| Model: BRG-G1b | Date: 8-May-12 | No.: RJ028001k |

| Subject: Firmware Release Note: Engine/Controller | | Prepared by: Y. Saitoh | |

This RTB has been issued to announce the firmware release information for the **Engine/Controller**.

| Subject: Broken Pivot of Roller Tension Spring | | Prepared by: Junji Mochizuki | |

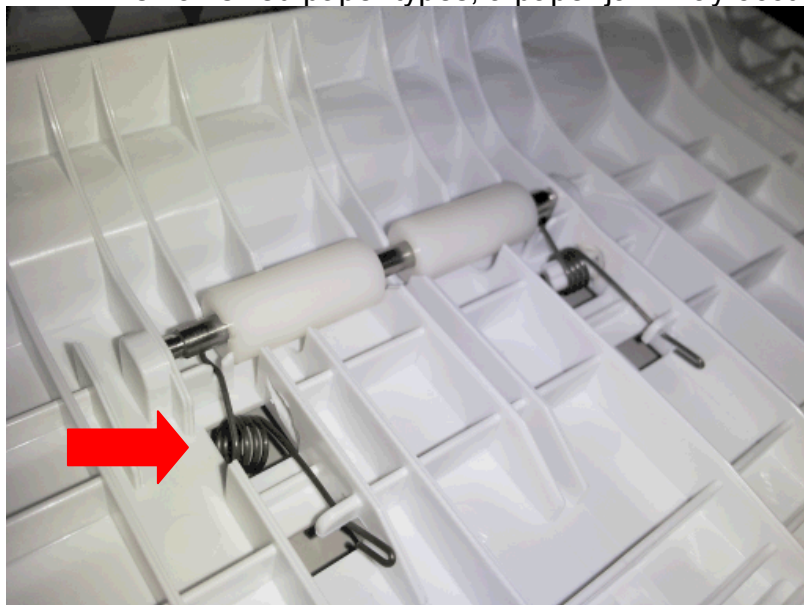
The fulcrum for the roller tension spring breaks.

The oil on the tension spring causes the plastic pivot to corrode, reducing its strength.

The tension spring was changed to an oil-free nickel-plated spring (Applied from: Sept. 2012 production).

If a paper jam or paper skew occurs due to a broken fulcrum, replace the guide plate assembly (**J0252758**). [If this problem occurs, a replacement part can be ordered with a retrofit part number J0271551 \(=J0252758\).](#)

| Subject: Collar – Paper Feed Roller | | Prepared by: Junji Mochizuki |

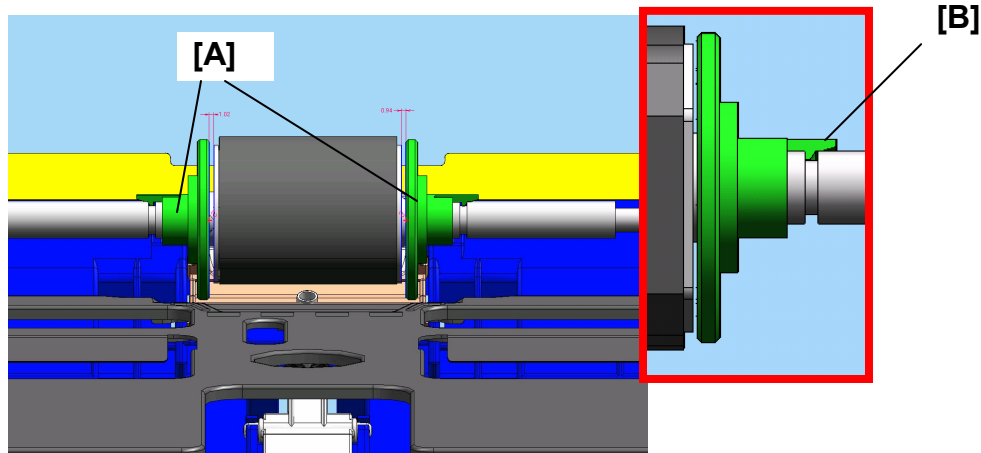
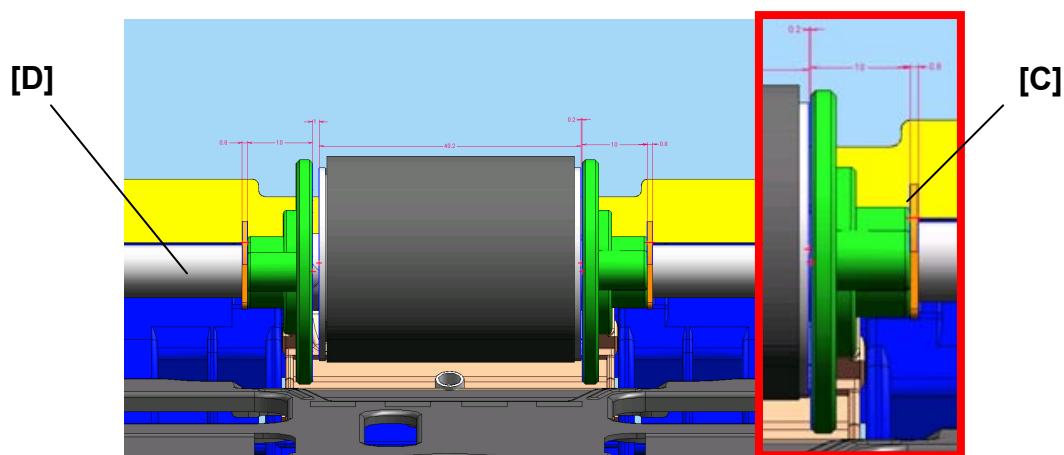
To eliminate the scraping noise of the feed roller collars [A], the stopper [B] of the collar has been changed to a retaining ring [C]. The shaft [D] of the roller has also been changed to fit the groove with the retaining ring.

The part numbers have been changed as follows.

| Old P/N | New P/N | Description | Q'ty | I/C |
|----------|----------|----------------------------|------|-----------------------|
| J0253014 | J0343014 | Collar - Paper Feed Roller | 2 | X/X X/O as a set |
| J0253045 | J0253043 | Shaft – Paper Feed | 1 | X/X |
| | A0100011 | Retaining Ring | 2 | |
